Staff Report

Applicant:		
Pine Point Mining Limited		
Location:	File Number(s):	
Pine Point, NT	MV2020C0017 MV2020L8-0012	
Date Prepared:	Date of Board Meeting:	
April 5, 2021	April 13, 2021	
Subject:		
Preliminary Screening Determination – Type A Licen	ce and Permit Applications

Review Comment Table

Board:	MVLWB	
Review Item:	Pine Point Mining Limited - Land Use Permit and Water Licence Applications (MV2020L8-0012 MV2020C0017)	
File(s): MV2020C0017 MV2020L8-0012		
Proponent:	Pine Point Mining Limited	
Document(s):	Engagement Log (278.65 kb) Engagement Plan V2.1 (285.36 kb) Land Use Permit Application (681.63 kb) Project Description (4.78 mb) Screening Impact Assessment (7.1 mb) Studies Undertaken to Date and Traditional Knowledge (232.88 kb) Spill Contingency Plan V1.0 (7.1 mb) Waste Management Plan V.1 (761.49 kb) Wildlife Protection Plan V1.0 (1.6 kb) Water Withdrawal Plan V1.0 (53.9 kb) PPML RECLAIM Estimate (550.5 kb) Closure and Reclamation Plan V1.0 (2.92 mb) Mapbooks with Overview (4.95 mb) Bedrock Sampling Management Plan Framework (552.84 kb) Application Cover Letter (522.8 KB) Water Licence Application (630.75 kb) Groundwater Management Plan Framework (701.23 kb) Work

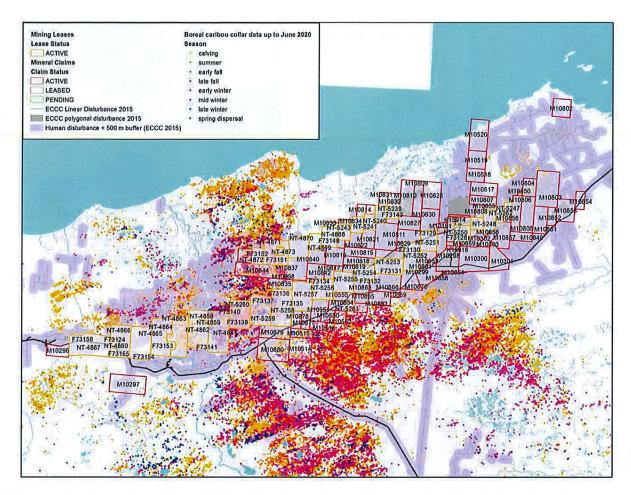
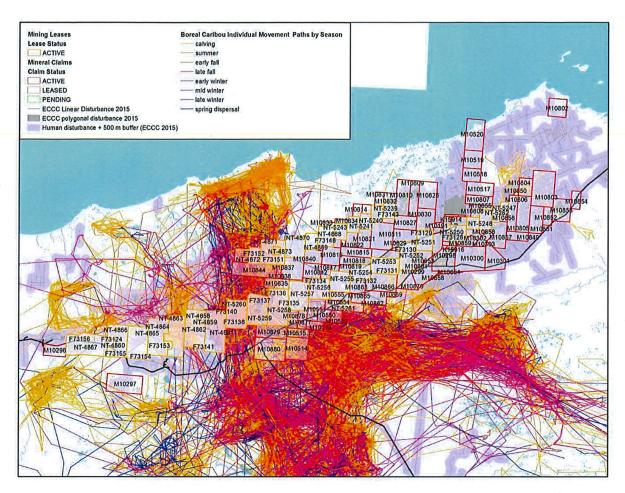
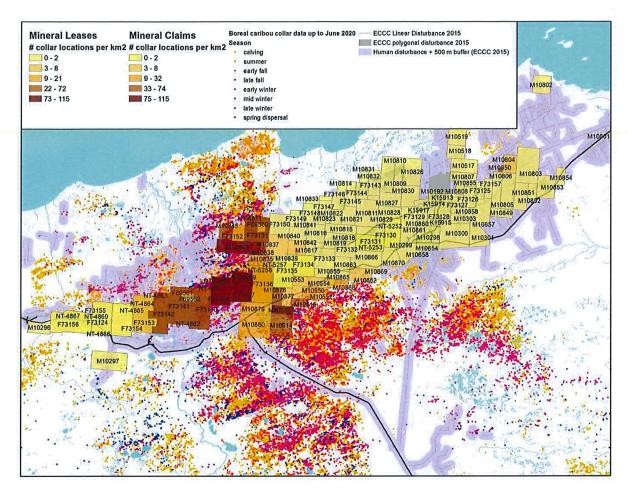
Proponent's CEP area, particularly to the west and south of the most heavily disturbed areas of the former Pine Point Mine site. Attached are two figures showing collar locations and movement paths of individual boreal caribou colour coded by behavioural season. Figure 1 and Figure 2 display movement data from 27 caribou collared between 2015 and 2020, and indicate year-round use of the western half of PPML's mineral leases and mineral claims, with a prominent north-south movement corridor across mineral leases NT-4858, NT-4859, NT-5258, NT-5259, NT-5260, NT-4861, NT-4862, NT-4863, NT-4864, NT-4871, NT-4872, and NT-4873, and mineral claims (those that don't overlap with the mineral leases listed above) M10835, M10837, M10838, M10842, M10844, M10845, M10550, M10551, M10552, M10553, M10554, M10862, M10868, M10869, M10877, M10878, M10879, M10880, M10514, M10515, M10516. Figure 3 illustrates the minerals leases and claims with the highest densities of collar locations. Although PPML's Screening Impact Assessment acknowledges that the project area overlaps with the range of boreal caribou, it is insufficient to properly assess the impact of their operation on the local boreal caribou population. The screening assessment identifies that there will be direct habitat loss, sensory disturbance to wildlife, and potential for direct mortality; however, it does not specifically assess the potential significance of these impacts on boreal caribou, nor does it consider the cumulative impacts of their project alongside other past, present and reasonably foreseeable developments in the context that boreal caribou is a threatened species in the NWT. PPML's Screening Impact Assessment concludes that most effects will be localized, and reversible, based on the assumption that many potential impacts will be mitigated by preferentially using

minimize impacts to caribou or to determine the extent of residual impacts to boreal caribou and habitat resulting from the proposed activities. Recommendation 1) The GNWT recommends that PPML provide more detailed information on the specific locations, timing and frequency of activities proposed for this project, as well as an estimate of how much new habitat disturbance will occur as a result of widening existing trails, creating new access trails, and clearings for drill sites, test pits, and water pipelines, so that impacts to boreal caribou and their habitat can be properly assessed.		
3	None	Comment None Recommendation 2) The GNWT recommends that the Board require further studies under Mackenzie Valley Land Use Regulations, section 22 (2) (b). It is the GNWT's understanding that the Board cannot make a preliminary screening decision until after further studies have been completed.	Feb 2: Noted	The Board made a 22(2)(b) determination for Permit MV2020C0017 on January 20, 2021.

4	None	Comment None Recommendation 3) The GNWT recommends that PPML work with the GNWT to conduct a population survey to determine how many boreal caribou occur within the project area.	Feb 2: PPML is willing to discuss this with the GNWT.	See Board Decision for GNWT, Comment 2.
6	and Monitoring	Comment The GNWT appreciates that Pine Point Mining Ltd has included a Wildlife Protection Plan - Ver. 1.0 in its application for the proposed Confirmation and Exploration Program which is consistent with advice provided in the WMMP Process and Content Guidelines that it is a best practice for all Proponents to submit a basic (Tier 1) WMMP with their application for authorizations. The GNWT notes that PPML's proposed Confirmation and Exploration Program is an advanced mineral exploration program requiring a Type A Water Licence which, according to Section 3.1.1 of the WMMP Guidelines, is a type of project deemed always likely to satisfy one	review priorities for the CEP, with which to prepare a	See Board Decision for GNWT, Comment 2.

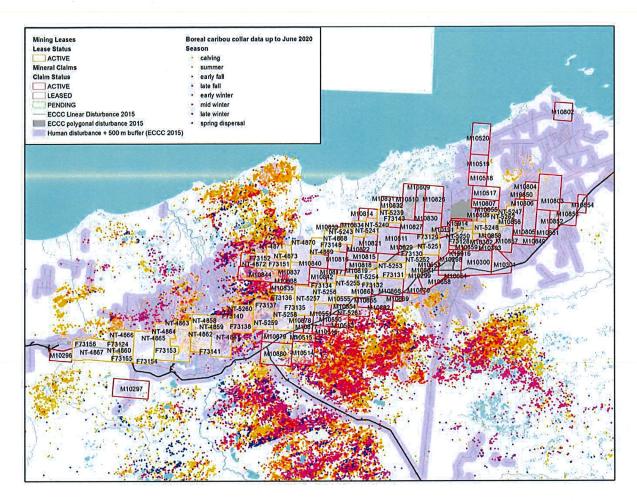
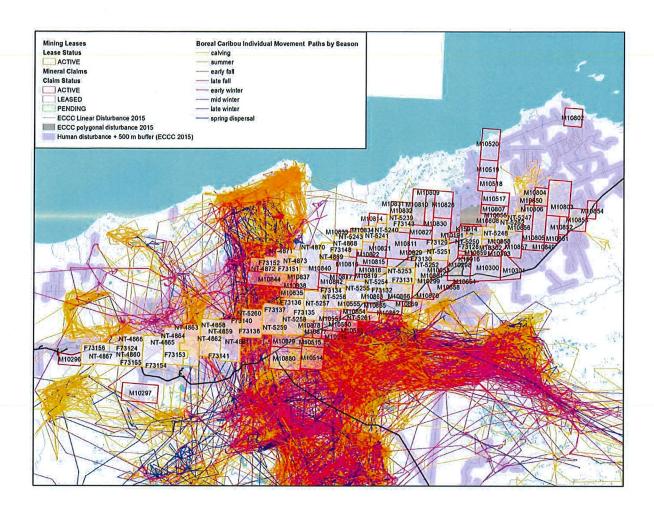
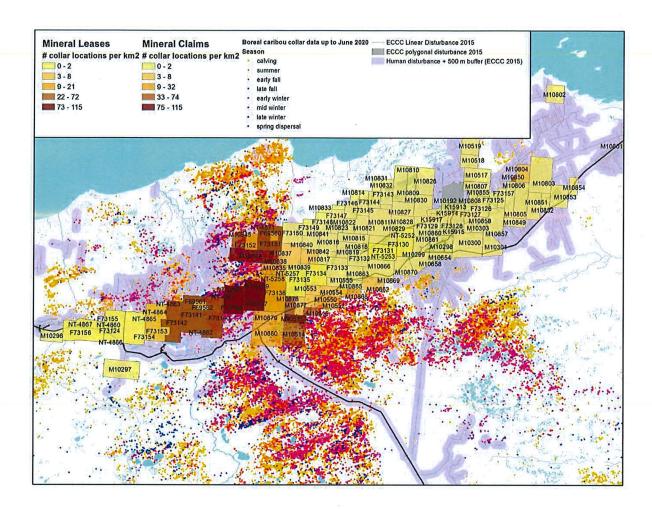
Attached to this letter are three figures showing collar locations and movement paths of individual boreal caribou colour coded by behavioural season. Figure 1 and Figure 2 display movement data from 27 caribou collared between 2015 and 2020, and indicate year-round use of the western half of PPML's mineral leases and mineral claims. Figure 3 illustrates the minerals leases and claims with the highest densities of collar locations (see Appendix A for more details).
